Access Compliance Report

Public Rights-of-Way

Intersection ID: 53391	Main Street: EBBETS_RD	Cross Street: VAWTER_DR	Location: NE
ADA ID: 2247245CFFD6	Ramp Type: Perp	Initial Pass/Fail: Fail	Overall Compliance: No
		Severity Score: 17.5

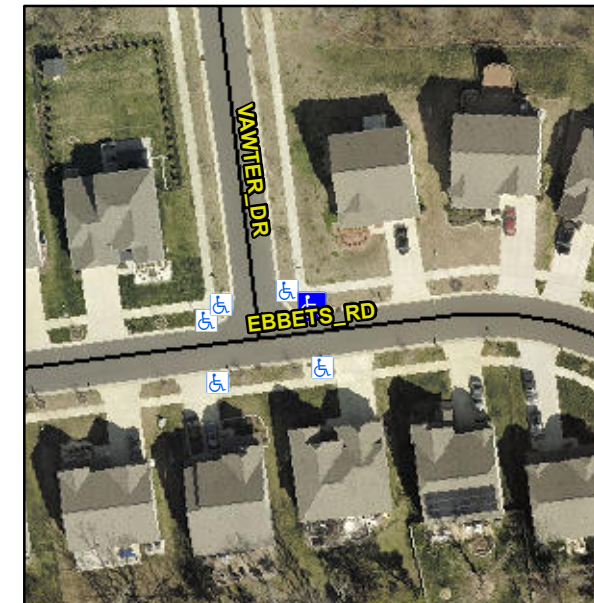
Not Found, R304.5.1

Compliance	Description	Data	Compliance	Description	Data
N/A	Ramp Length (in)	95.0	Yes	Ramp Slope (%)	7.5
No	Ramp Width (in)	33.5	Yes	Ramp XSlope (%)	1.6
N/A	Flare Type LT	N/A	N/A	Flare Type RT	N/A
N/A	Flare Slope LT (%)	N/A	N/A	Flare Slope RT (%)	N/A
N/A	Flare Traversable LT?	N/A	N/A	Flare Traversable RT?	N/A
N/A	Landing Length (in)	N/A	N/A	DWS Provided?	N/A
N/A	Landing Width (in)	N/A	N/A	DWS Contrast?	N/A
N/A	Landing Slope (%)	N/A	N/A	DWS Length (in)	N/A
N/A	Landing X Slope (%)	N/A	N/A	DWS Full Width?	N/A
N/A	Landing Curb? (Y/N)	N/A	N/A	DWS Offset (in)	N/A
N/A	Shared Landing?	N/A			
N/A	Gutter Ponding?	N/A	N/A	Gutter Slope (%)	N/A
N/A	Gutter Lip Ht (in)	N/A	N/A	Gutter X Slope (%)	N/A
N/A	Painted X Walk1?	No	N/A	Painted X Walk2?	N/A
	X Walk 1 Direction	To S		X Walk 2 Direction	N/A
N/A	X Walk 1 Width (in)	N/A	N/A	X Walk 2 Width (in)	N/A
	X Walk 1 Slope (%)	2.1		X Walk 2 Slope (%)	N/A
	X Walk 1 X Slope (%)	2.7		X Walk 2 X Slope (%)	N/A

Remove & Replace Entire Ramp.
